AMENDMENTS TO THE DRAWINGS:

REMARKS

Claims 1-29 are pending and rejected. Claims 1, 14, and 24 are amended hereinabove. In response to the drawing objections and the 35 U.S.C. §112 rejections, FIGURE 2 has been amended. Regarding the fact that “VDD in Fig. 2 is not seen in Fig. 4 and V_{pw} OR SUBSTRATE in Fig. 4 is not seen in Fig. 2” (page 3 of the Office Action), the Applicant notes that figures 2 and 4 are different parts of an SRAM device. Namely, FIG. 2 is peripheral circuitry that supplies V_{ADD} to the cell array (i.e. element 140 of FIG. 1) and FIG. 4 is the SRAM cell (i.e. element 115 of FIG. 1).

V_{DD} (or $V_{DDI/O}$) FIG. 2

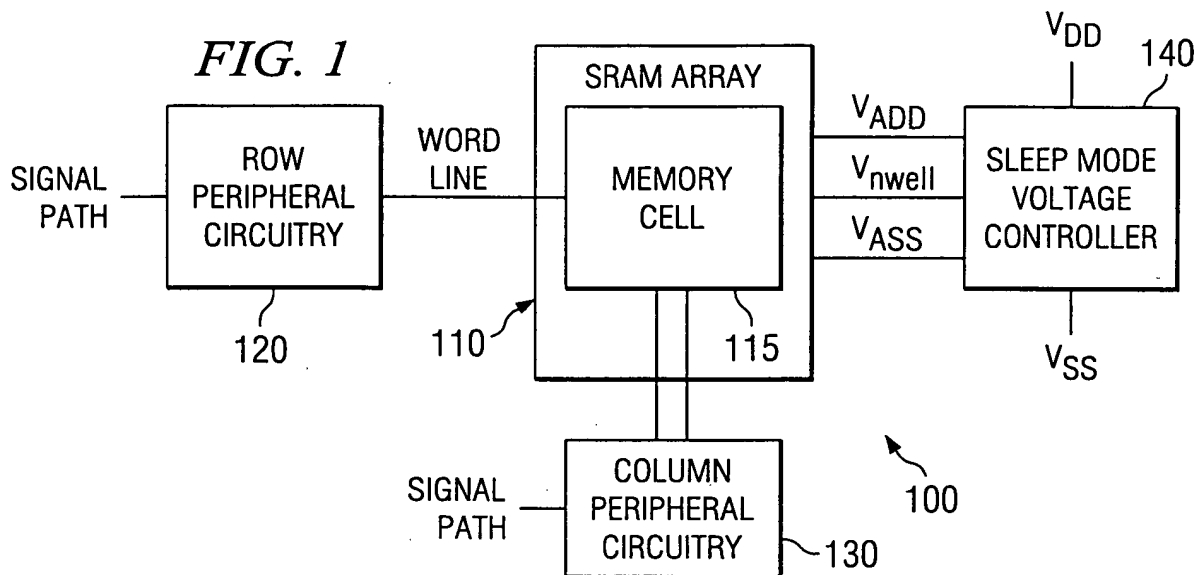
The attached sheets of drawings include changes to FIGURE 2, as indicated in red ink on the enclosed annotated sheets. These sheets, which include FIGURES 1-4, replace the prior amended sheets, which included FIGURES 1-4.

Regarding the rejection of Claims 2 and 15 on page 3 of the Office Action, the relationship between V_{ADD} and V_{well} is explained in paragraph 0040. The “how” is shown by the example circuit configuration of FIG. 2.

Regarding the rejection of Claim 3 on page 4 of the Office Action, the relationship between V_{ASS} and the substrate voltage is explained in paragraphs 0025, 0027, 0029, and 0040. The “how” is shown by the example circuit configuration of FIG. 2.

Regarding the rejection of Claims 4 and 16 on page 4 of the Office Action, the “how” is shown by the example circuit configuration of FIG. 2 and is explained in paragraph 0041.

Regarding the rejection of Claims 7 and 19 on page 4 of the Office Action, the “how” is shown by the example circuit configuration of FIG. 2 and is explained in paragraphs 0027 and 0043. The Applicant notes that FIG. 2 is “an embodiment of a sleep mode voltage controller” that is “constructed according to the principles of the present invention” (paragraph 0032). Moreover, the Applicant notes that the controller may use any combination of fuses, transistors, diodes, ROM, or LDO, as explained in paragraph 0043. Therefore, the Applicant respectfully traverses the statement in the Office Action (page 4) that the sleep mode voltage controller “must” comprise the example shown in FIG. 2. The Applicant submits that he is not limited only to the FIG. 2 example circuit, rather “those skilled in the art should understand that they can make various changes, substitutions and alterations...without departing from the spirit and scope of the invention in its broadest form” (paragraph 0045).
